EXHIBIT H - CONDITIONS OF APPROVAL

DRB Recommended Conditions of Approval:

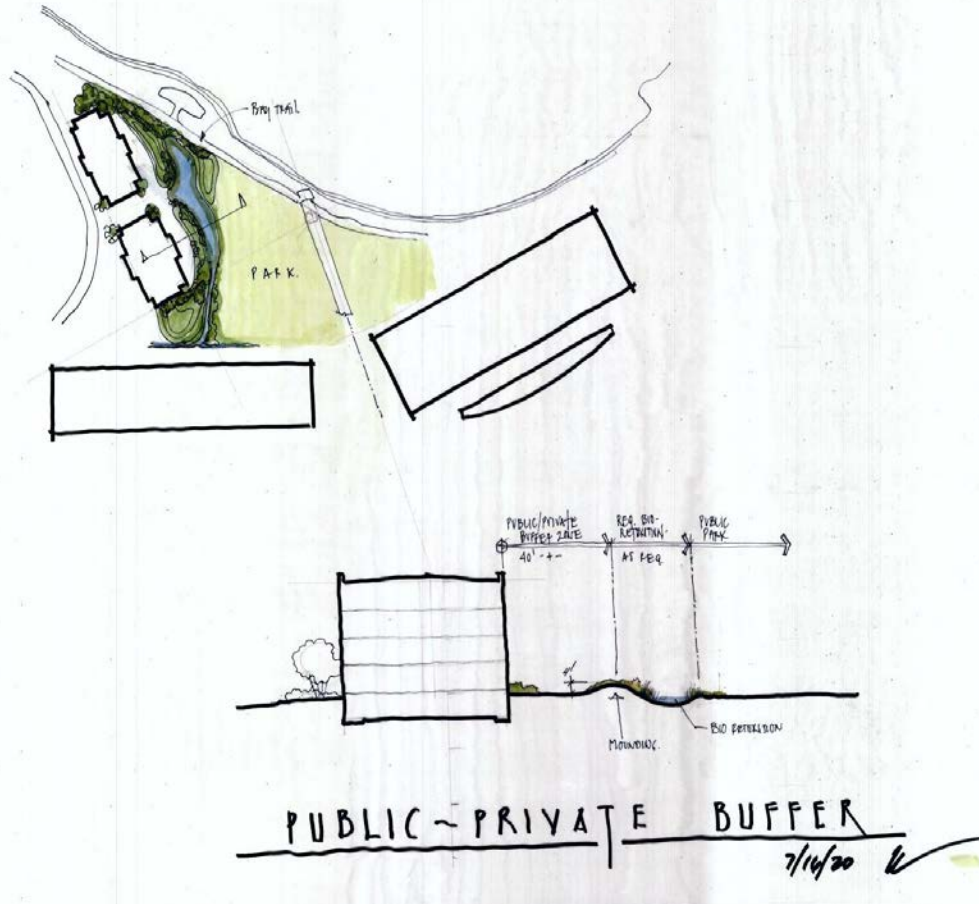
7. **Supplemental information** that was attached to the DRB on 7-21 via email from Staff shall be adopted into the Design Guidelines including option B of the shoreline park.
8. **Public private buffer zone:** When a public park ~~or public space~~ interfaces with a private residential zone, a buffer zone shall be established at the ground floor. The dimension of this zone will vary with the site but at no time shall it be less

than 20 feet. This buffer can be inclusive of required setbacks. A visual break consisting of landscaped berms or dense landscaping or landscape wall shall be considered. See illustrations example below.
